## Sparex Service Info

TD43813/4

Part Nr. S.43813/ S.43814

Perkins – A3.152 AD3.152

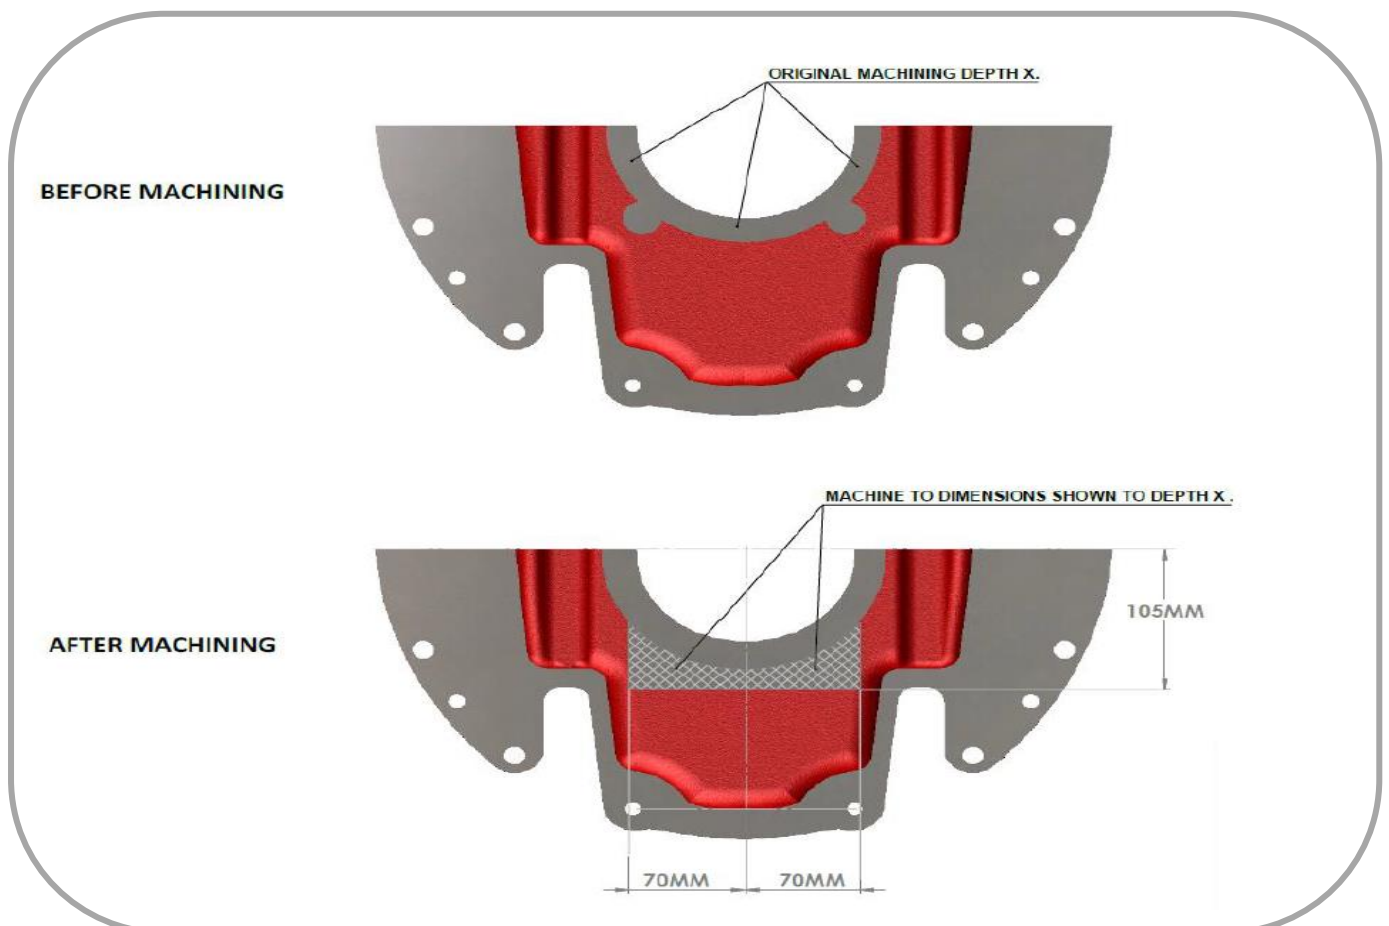
Info: Sump Modification required when replacing Perkins A3.152 and AD3 152 short motors fitted with rope type rear main oil seals fitted between 1959 and 1975.
